SERVICE BULLETIN

NUMBER: SB 500-52-001, REV B
MODEL: ECLIPSE EA500
SUBJECT: DOOR LOCK HANDLE REPLACEMENT

**Door Release Handle
Figure 1 (Sheet 1 of 1)**

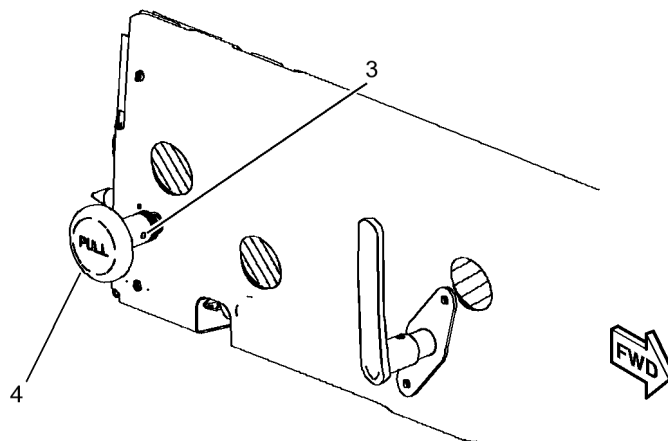
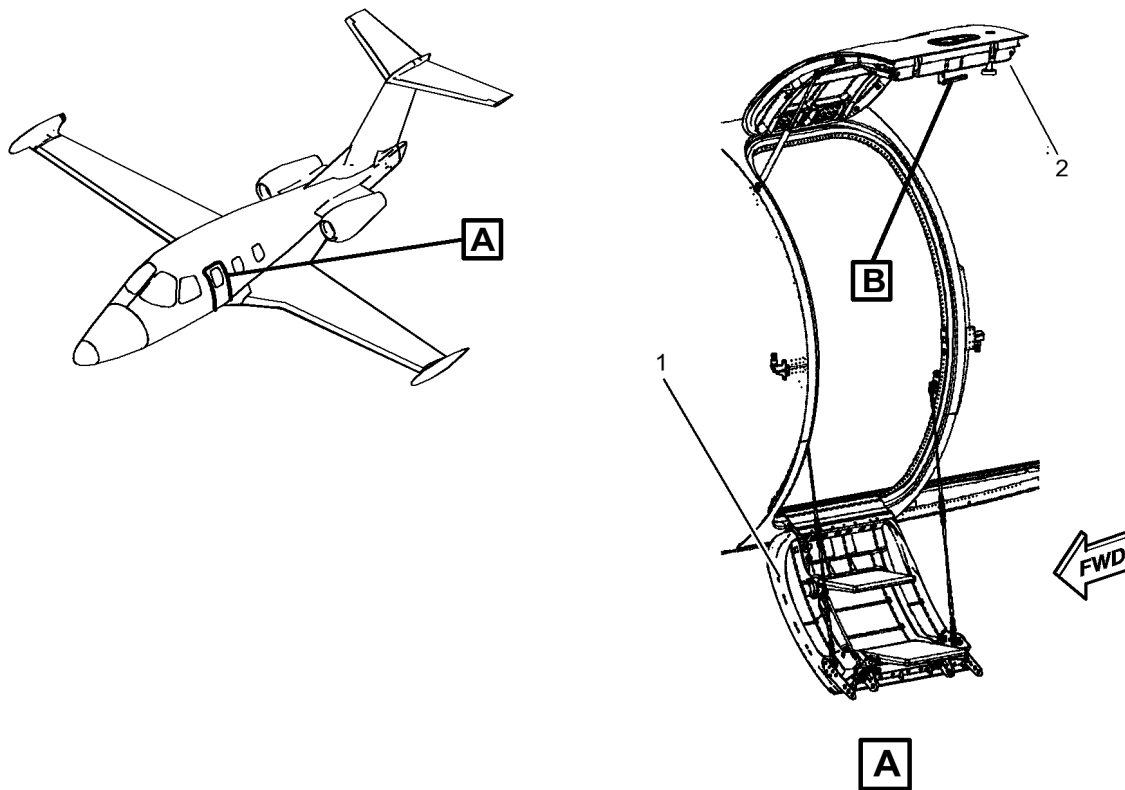
This Service Bulletin replaces Door Lock Handle P/N 52-114458-1002 with P/N 52-114458-1003. The effectivity of this Service Bulletin has been reduced.

- (1) Make aircraft safe for maintenance. Refer to AMM - 20-00-01-051-801 - MAKE SAFE FOR MAINTENANCE.
- (2) Open upper door assembly (2, Figure 1).
- (3) Open lower door assembly (1, Figure 1).
- (4) From inside aircraft, lower, but do not close or latch the upper door assembly.
- (5) Remove set screw (3, Figure 1) that attaches lock handle (4, Figure 1) to lock handle pin. Retain set screw for use with new handle.
- (6) Remove lock handle (P/N 52-114458-1002) (4, Figure 1) from lock handle pin.
- (7) Put lock handle (P/N 52-114458-1003) (4, Figure 1) on lock handle pin.
- (8) Attach lock handle (4, Figure 1) to lock handle pin with set screw (3, Figure 1) . Tighten set screw (3, Figure 1) until lock handle (4, Figure 1) on lock handle pin does not move.

CAUTION: BE CAREFUL NOT TO OVER TORQUE SET SCREW.

- (9) Do Adjustment/Test of the upper door latch/lock. Refer to AMM 52-00-00, SUBTASK AMM-52-00-00-071-701-010.
- (10) Remove all tools, equipment and unwanted material from the work area.
- (11) If all other maintenance is complete, return the aircraft to service. Refer to AMM-20-00-02.
